APPLICATION NO.	FILING DATE	FIRST NAMED INVENTOR	ATTORNEY DOCKET NO.	CONFIRMATION NO.
10/799,340	03/12/2004	Doug Wroblewski	0644-032407	6222

Office Action Summary	Application No. 10/799,340	Applicant(s) WROBLEWSKI, DOUG	
	Examiner DANIEL KENNY	Art Unit 3633

DETAILED ACTION

Annotated Fig. 1 (U.S. Pat. 6,269,495)

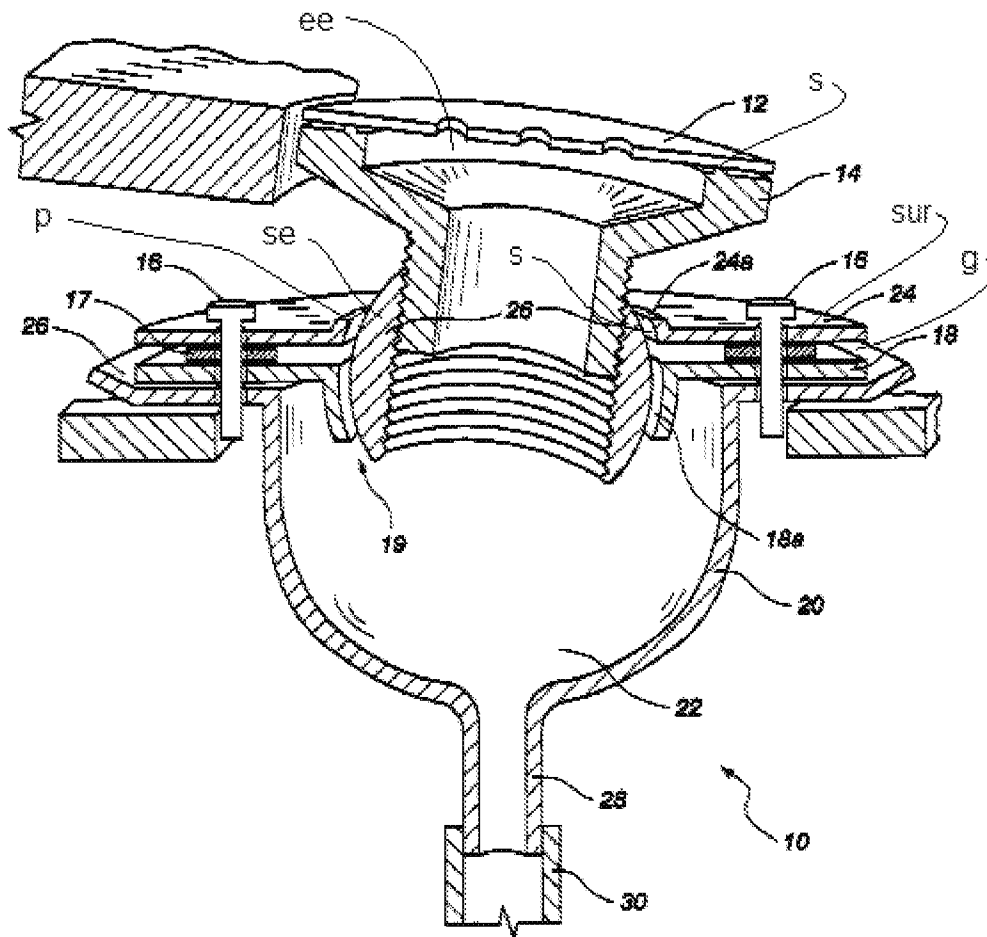
Claims 2-4, 6, 8, 9, and 19 - are rejected under 35 U.S.C. 102(b) as being anticipated by Sondrup (6,269,495).

Sondrup discloses a drain comprising:

Claim 8 - a drain body (18, 20) defining a drain cavity (22);

a frame (14 and se) having a securable end (se) received by said drain body and an exposed end (ee), said frame being rotatable relative to said drain body for adjusting the position of said frame exposed end;

a clamp (16, 24) for fixing said securable end of said frame to said drain body;
and

a grate (12) received by said exposed end of said frame, wherein said drain body comprises a ledge (18a) having a sloped surface, said frame securable end slidably engaging said surface of said sloped surface of said ledge when said frame is rotated relative to said drain body;

the clamp comprises a clamp body having a protrusion (p) for clamping said frame securable end to said drain body;

wherein said clamp further comprises a fastener (16) extending (in a radial direction) beyond said frame securable end and said clamp body and being threaded into said drain body (col. 3, lines 23 and 24).

Claim 9 - a drain body (18, 20) defining a drain cavity (22);

a frame (14 and se) having a securable end (se) received by said drain body and an exposed end (ee), said frame being rotatable relative to said drain body for adjusting the position of said frame exposed end;

a clamp (16, 24) for fixing said securable end of said frame to said drain body;
and

a grate (12) received by said exposed end of said frame, wherein said drain body comprises a ledge (18a) having a sloped surface, said frame securable end slidably engaging said surface of said sloped surface of said ledge when said frame is rotated relative to said drain body;

the clamp comprises a clamp body having a protrusion (p) for clamping said frame securable end to said drain body;

wherein said drain body comprises a fastener receiving member (18a) extending into said drain cavity whereby said clamp body protrusion is configured to clamp said frame securable end to said fastener receiving member.

clamp body having a protrusion for clamping said frame securable end to said drain body, and wherein said clamp body comprises a sloped drain body engaging surface (s) to provide a gap between a portion of said drain body engaging surface and said drain body.

Claims 2 and 21 – The frame securable end is circular.

Claims 3, 4, and 20 – The frame exposed end may have any shape (col. 4, lines 32 and 33).

Claim 6 – The frame exposed end comprises a seat (s), said grate being fixed to said seat.
